UNITED STATES PATENT AND TRADEMARK OFFICE

APPLICATION NO.	FILING DATE	FIRST NAMED INVENTOR	ATTORNEY DOCKET NO.	CONFIRMATION NO.
10/722,645	11/26/2003	Carlton Plunk	ZK522/03051	7326
27868	7590	07/25/2005	EXAMINER	
JOHN F. SALAZAR MIDDLETON & REUTLINGER 2500 BROWN & WILLIAMSON TOWER LOUISVILLE, KY 40202			REHM, ADAM C	
			ART UNIT	PAPER NUMBER
			2875

Office Action Summary	Application No. 10/722,645	Applicant(s) PLUNK ET AL.	
	Examiner Adam C. Rehm	Art Unit 2875

DETAILED ACTION

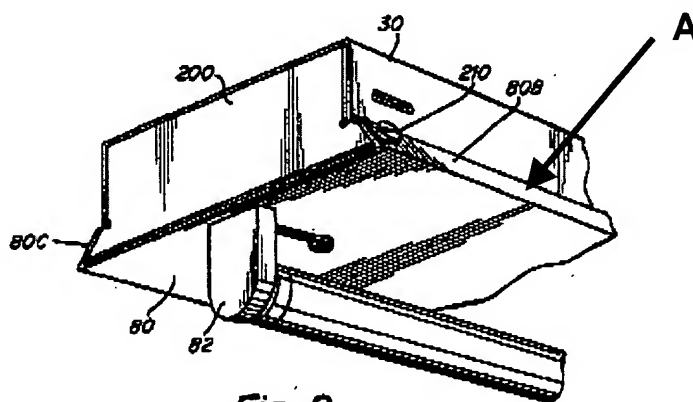
2. Claims 1-27 are rejected under 35 U.S.C. 102(b) as being anticipated by WEATHERS (US 6,210,019).
3. Regarding Claims 1-23 and 25-27, WEATHERS provides a retrofit unit for a fluorescent lighting fixture comprising a chamber (80A, Fig. 3) having:
 - An elongated protruding bottom wall with angled surfaces (Fig. 5 illustrates wall 80/80A/80B protruding outwardly from the fixture 30; see below Fig. 9, Ref A) for
